Product change information (PCN)

PCN No.:	AAB170051	Date:	05.04.2019
Products:	M17 ST... series

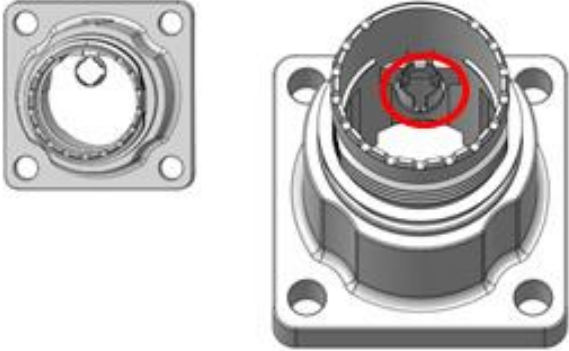
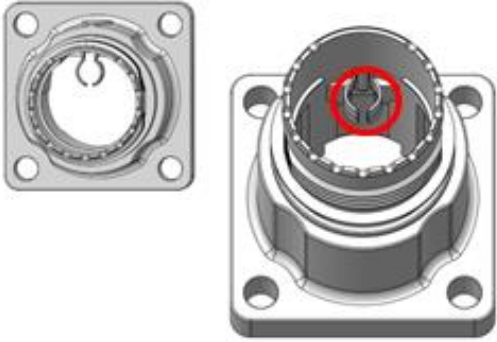
Description of change		
<input checked="" type="checkbox"/> Product appearance (fit)	<input checked="" type="checkbox"/> Product geometry (form)	<input type="checkbox"/> Product function (function)
Modification of the PE spring for the M17 housing ST... series		
<p>As part of the ongoing product improvement process, the shape of the PE spring is optimized for the listed products. This change has no influence on the mechanical and electrical properties of the connectors. This change does not affect any other technical or electrical data.</p>

Previous production status	Future production status
<p>Assembled condition</p> 	<p>Assembled condition</p> 
<p>Unassembled condition</p> 	<p>Unassembled condition</p>
